5.0 REVISIONS TO THE REVISED DRAFT EIR

The following chapter presents corrections, modifications and clarifications to text, tables and figures as presented in the RDEIR. These changes and corrections have been initiated by City of Petaluma staff (as Lead Agency), and/or have been made in response to public comments received on the RDEIR. Changes include revisions warranted or required to ensure accuracy and clarity of the environmental analysis. These changes made to the RDEIR constitute information that clarifies or amplifies or makes insignificant modifications to the adequate RDEIR (see *CEQA Guidelines* § 15088.5b). As such, the following changes do not require recirculation of the RDEIR.

As indicated in the Introduction to this document, the entirety of the Scott Ranch Project Final EIR consists of the RDEIR and its appendices, and this Response to Comments document. Thus, changes to the RDEIR presented below supersede the corresponding original text of the RDEIR. Throughout this chapter, newly added text is shown in underline format, and deleted text is shown in ~~strikeout~~ format. Changes are listed in the order in which they appeared in the RDEIR (e.g., **Chapter 1.0,

UPDATED FIGURE 4.3-2

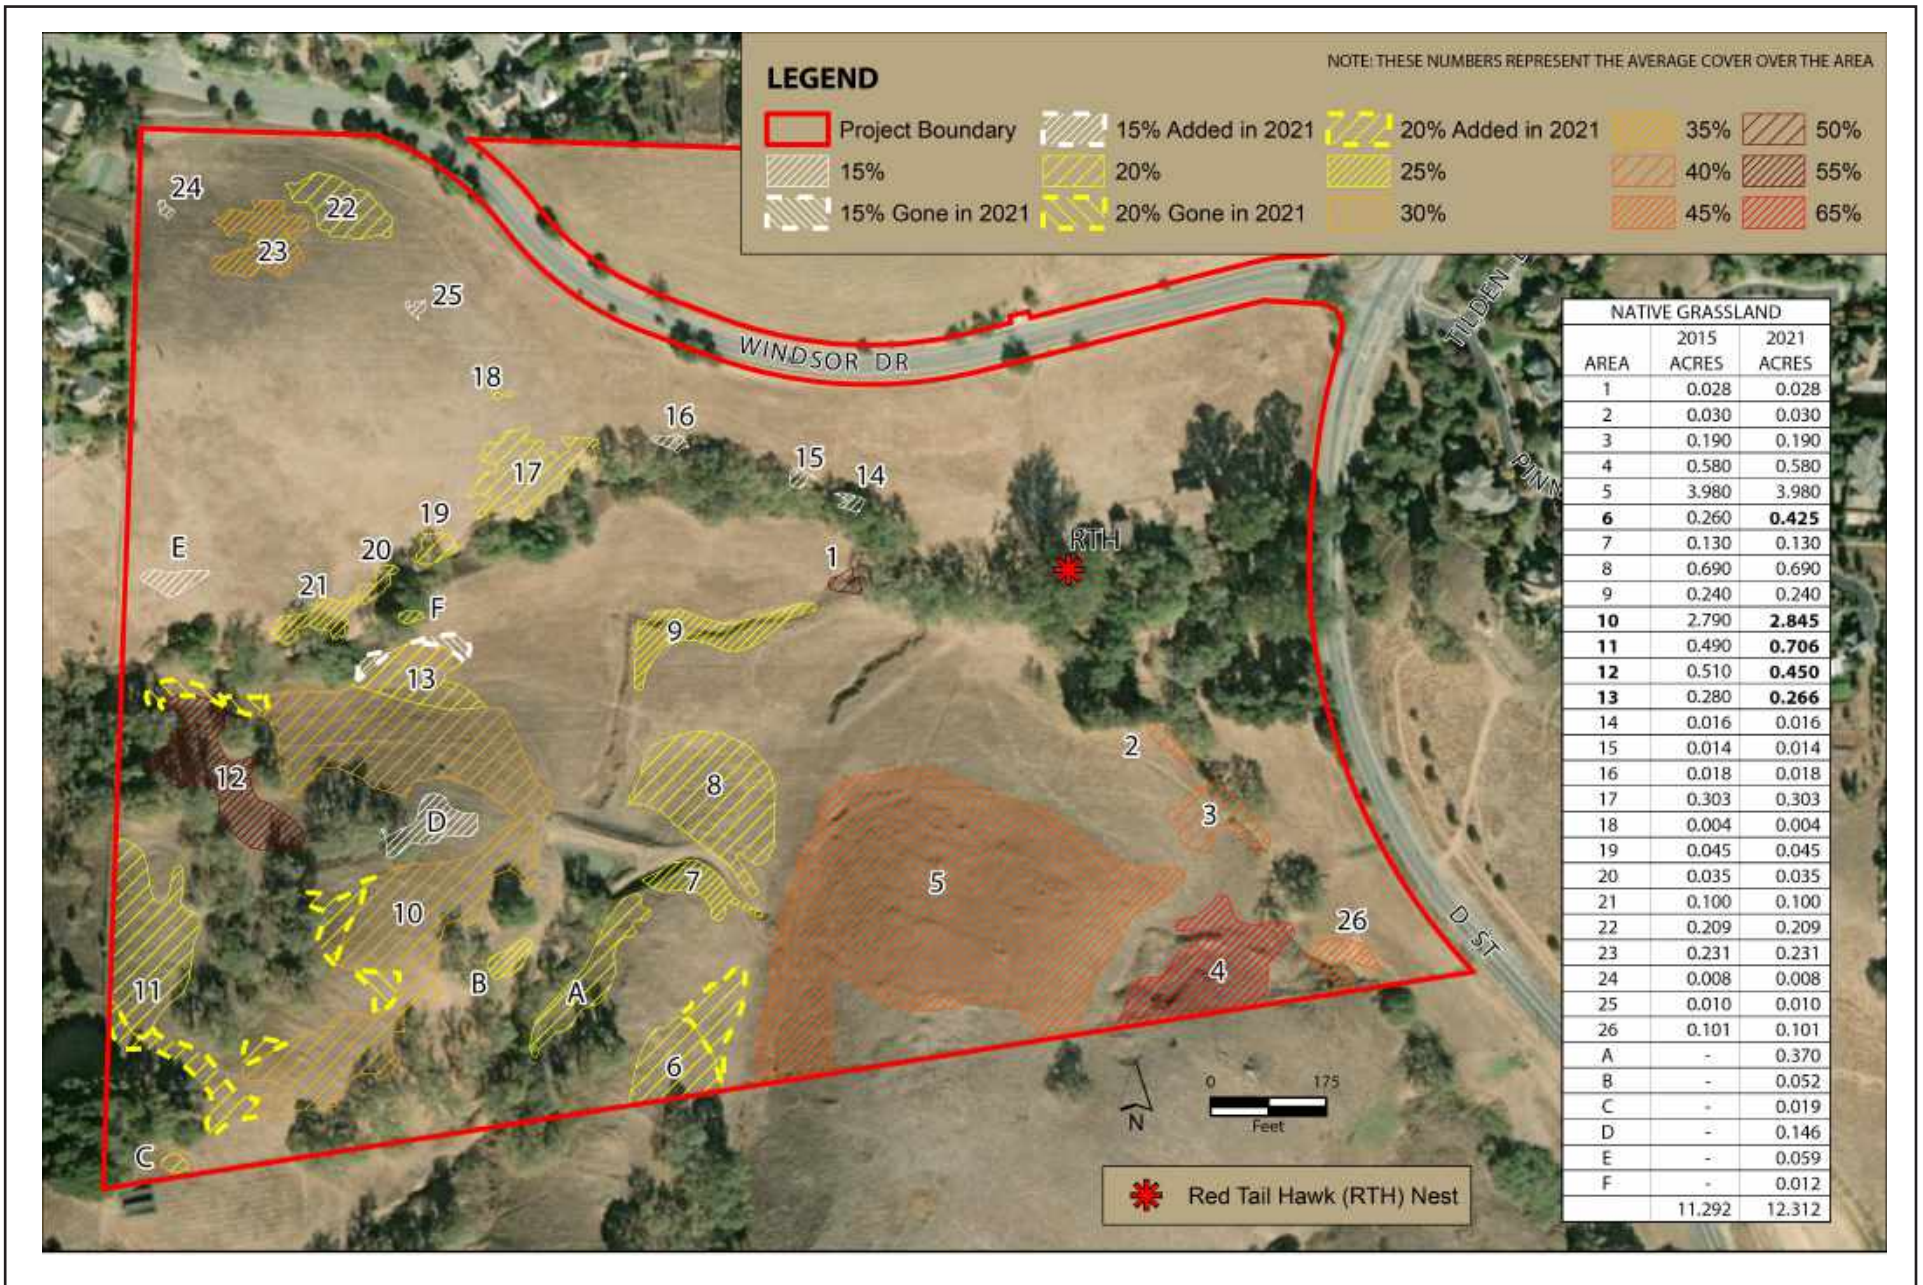
Figure number has been revised as follows: Updated Figure 4.3-2.

Figure has been updated to show the revised grassland footprints according to the surveys conducted after the publication of the RDEIR.

UPDATED FIGURE 4.3-3

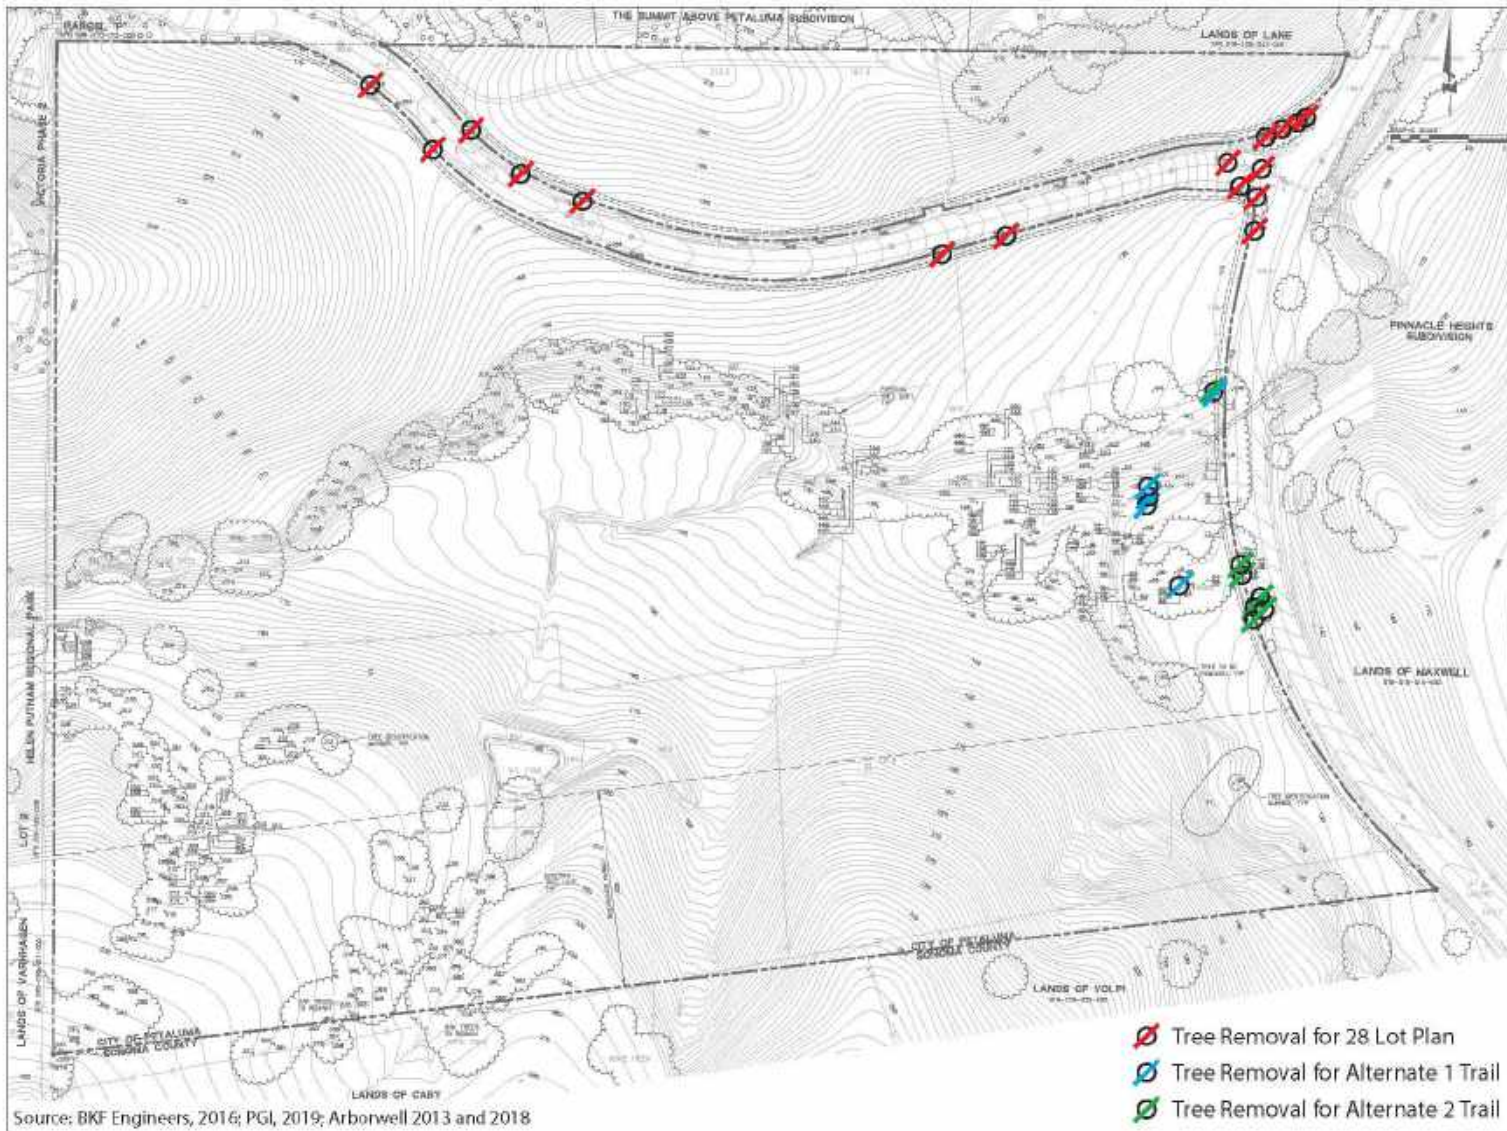
Figure has been replaced to show the correct number of trees that would be removed as part of the residential component. As revised, two trees along the south side of Windsor Drive would not be removed. The residential component would result in the removal of 16 trees onsite (with up to 3 trees as part of the offsite sidewalk improvements not shown on the figure). The park extension component would result in the removal of 11 trees.

UPDATED FIGURE 4.13-11

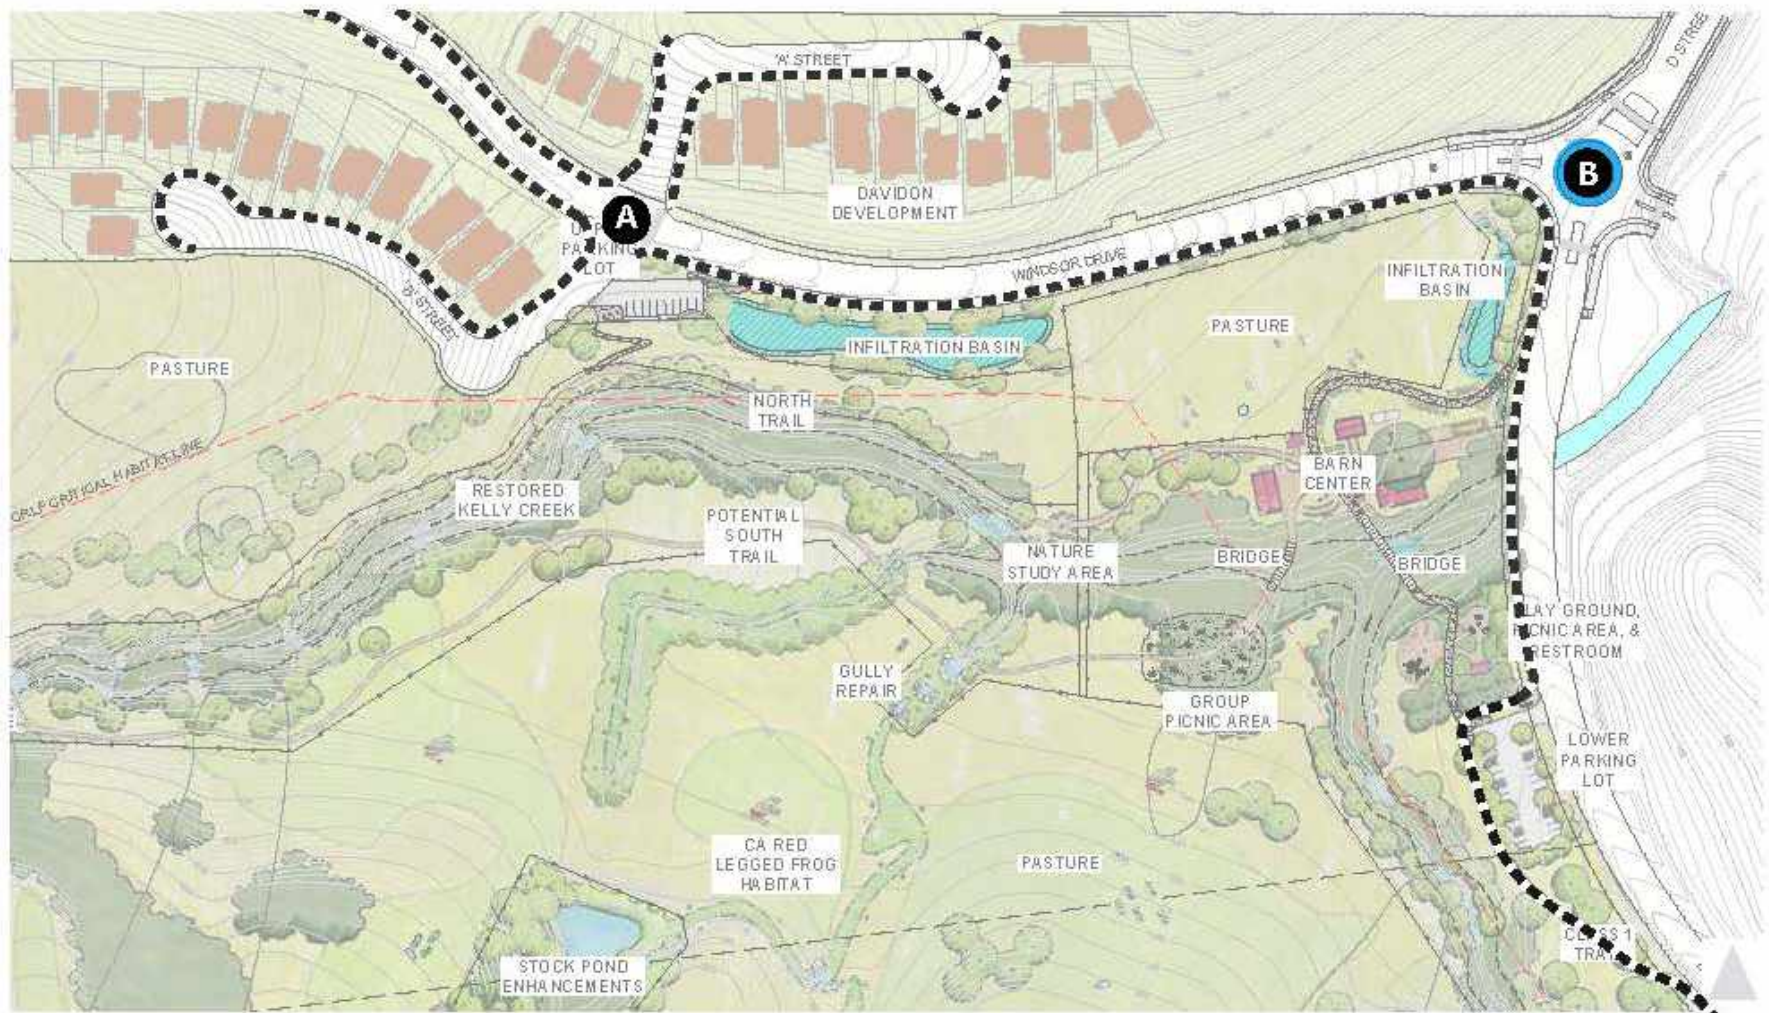
Page 4.13-57, Figure 4.13-11:

Figure has been updated to show the revised footprint of the residential component.

UPDATED FIGURE 4.15-3

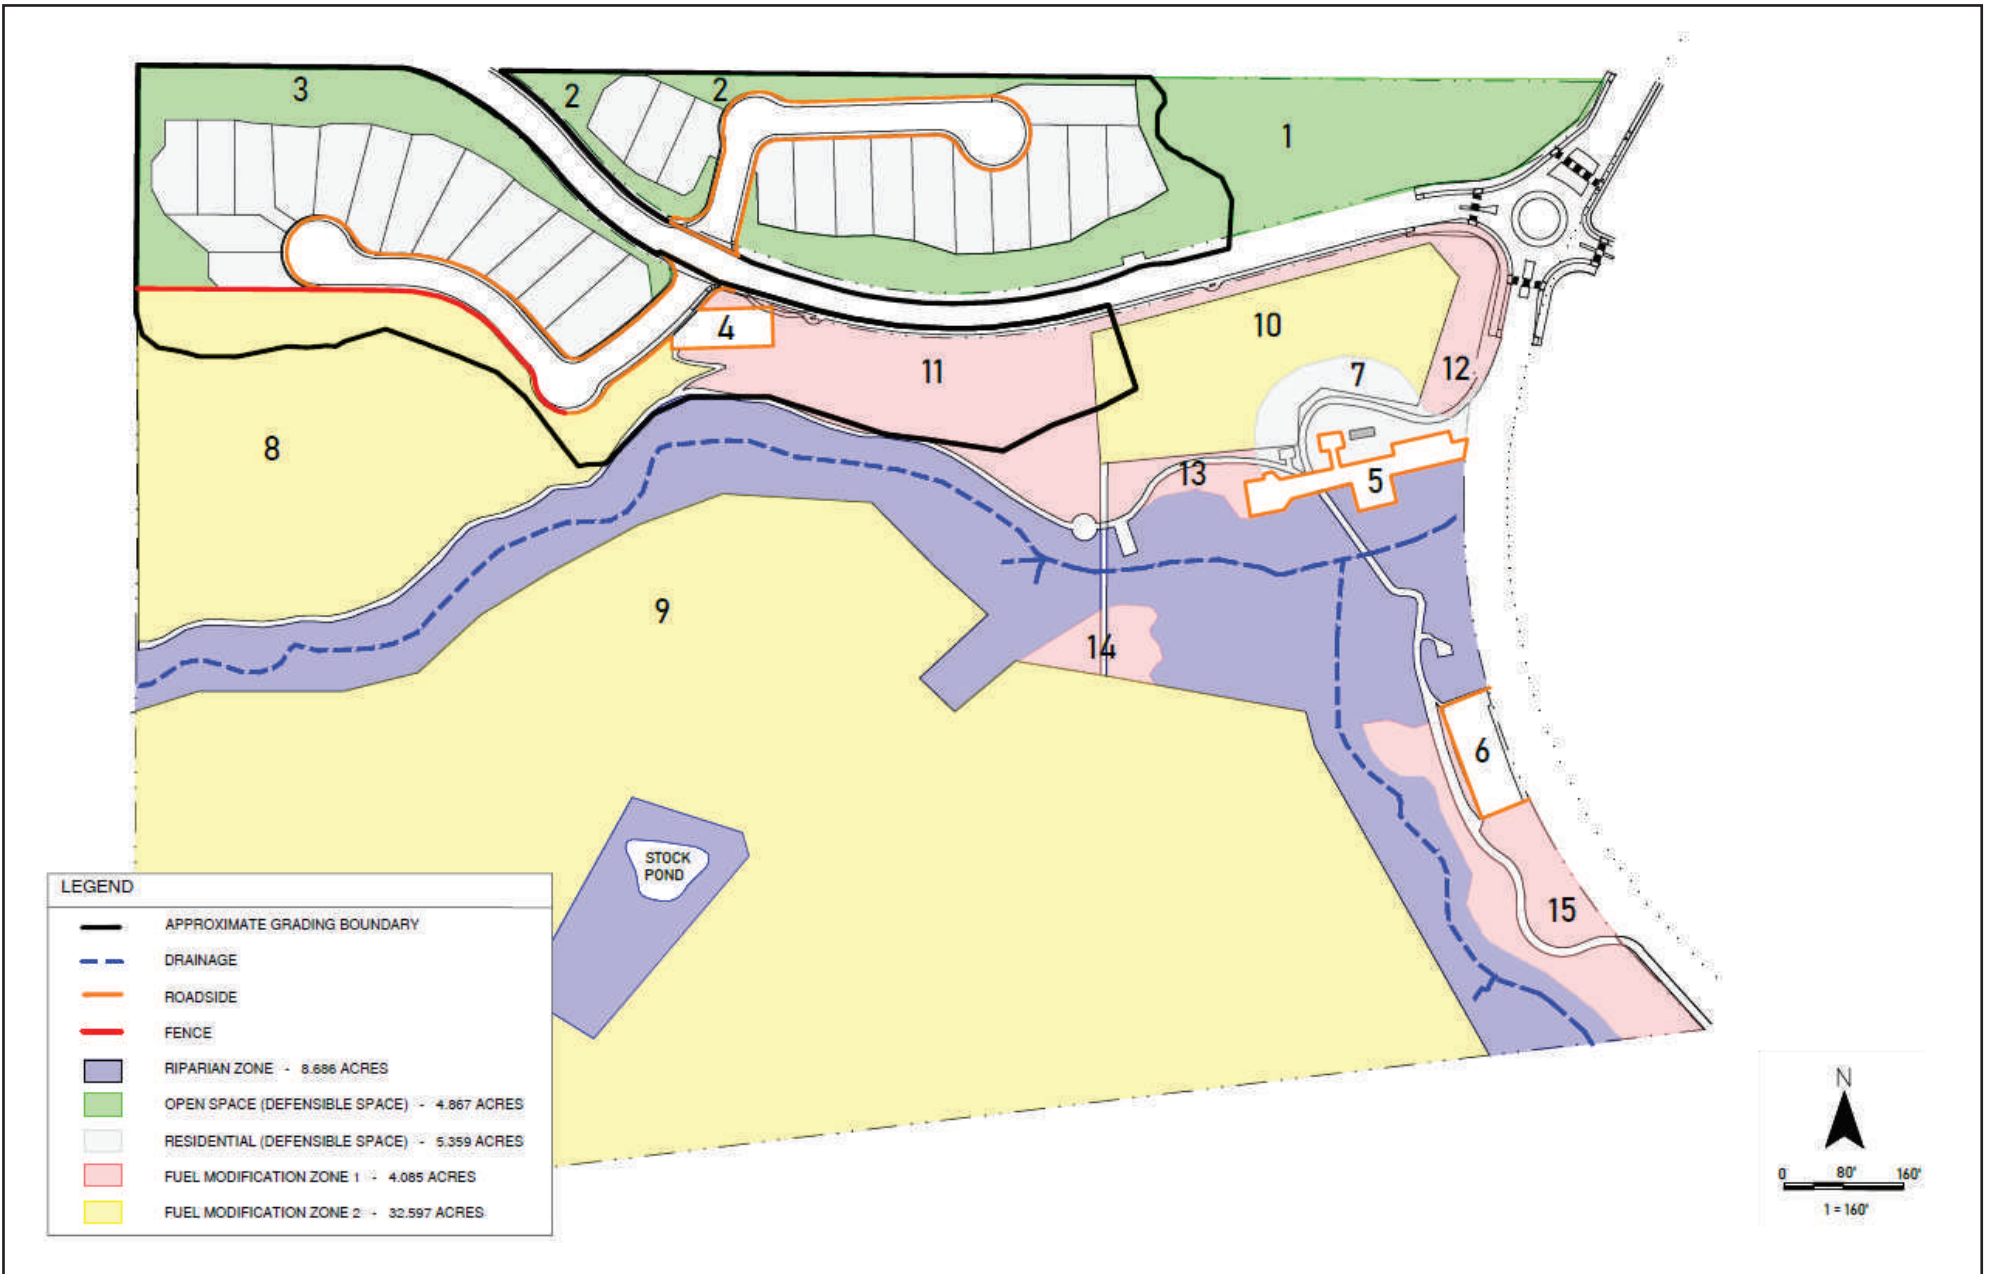
Figure has been updated to show the updated fuel management zones per the *Revised Fuel Management Plan*.

Figure Number has been revised as follows: **Updated Figure 4.15-3**
